Name: SIPPO CREEK RESERVOIR DAM

File No: 0614-012

SIPPO CREEK RESERVOIR DAM - CONCEPT PLAN

SIPPO CREEK RESERVOIR DAM
June 2010 versus December 2016
FILE NUMBER: 0614-012

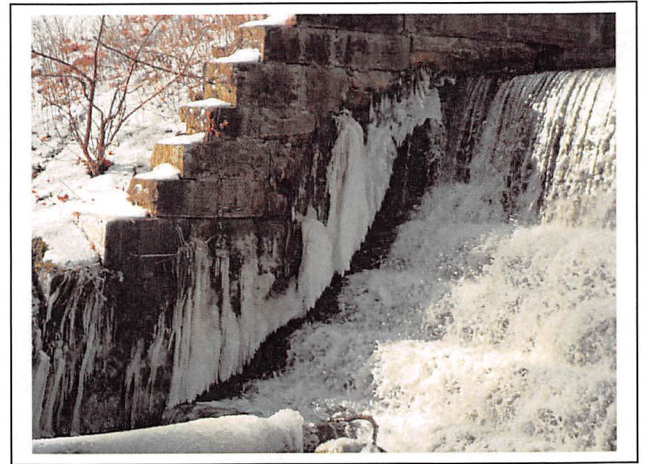
View of the brick cutoff wall on the left side of the spillway in 2010. Note that the bricks are becoming displaced.

View of the brick cutoff wall on the left side of the spillway in 2016. Note that another layer of bricks has been displaced.

View of the right principal spillway side wall in June 2010. This wall has remained for the most part unchanged.

View of the right principal spillway side wall in 2016. The icicles indicate that water is flowing between the stones.

SIPPO CREEK RESERVOIR DAM
June 2010 versus December 2016
FILE NUMBER: 0614-012

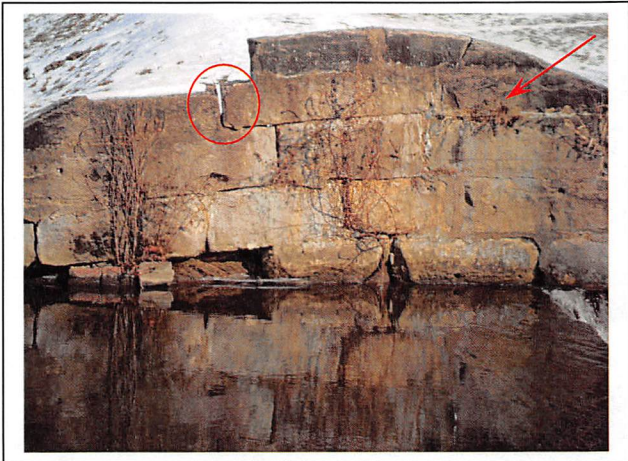
View of left principal spillway side wall in June 2010.

View of the upstream end of the left principal spillway wall in 2016. Note that the stones have shifted and now daylight can be seen between the stones.

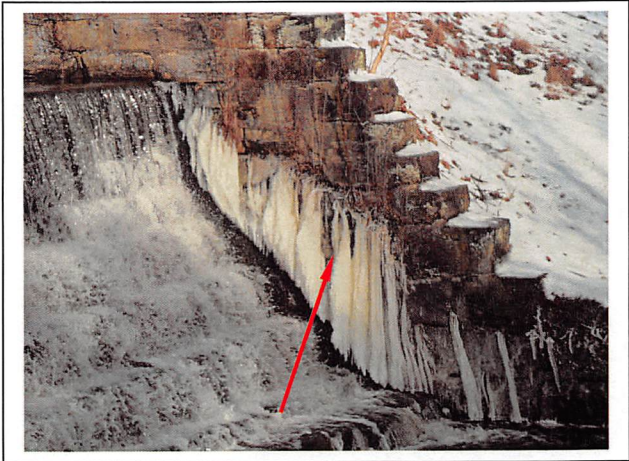
View of the left principal spillway wall in 2016. Note again that the stones have shifted and now daylight can be seen between the stones. Also note that vegetation is growing between more of the joints, indicating the joints have separated.

View of the left principal spillway wall in 2016. The icicles indicate water is flowing through the joints of the wall.
